RE: WHITE WATERS LTD – 893 KAKAPO ROAD TE ANAU
MEGAPOND STRUCTURAL REVIEW

The purpose of the visit was to review and assess the present structural integrity of the pond structure and assess its suitability for ongoing use as on farm effluent storage.

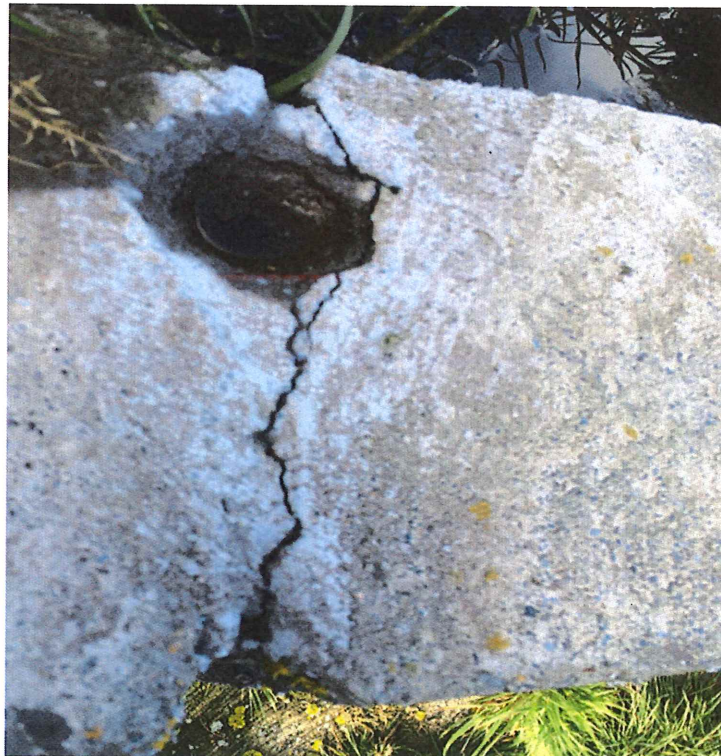
Typical overflow down joint from overfull pond at low side of the pond. Grout infill and sealant are all in good condition.

View of shrinkage crack in grout through top of the panel and low level of grout in shear key. Several areas like this noted, which require cleaned out and additional grout.

External view of previous top joint showing sealant in good condition and minor damp concrete at the lower level.

Typical view of ground level ring beam and close up view in RH photo of typical shrinkage crack initiated at smaller centre panel rib.
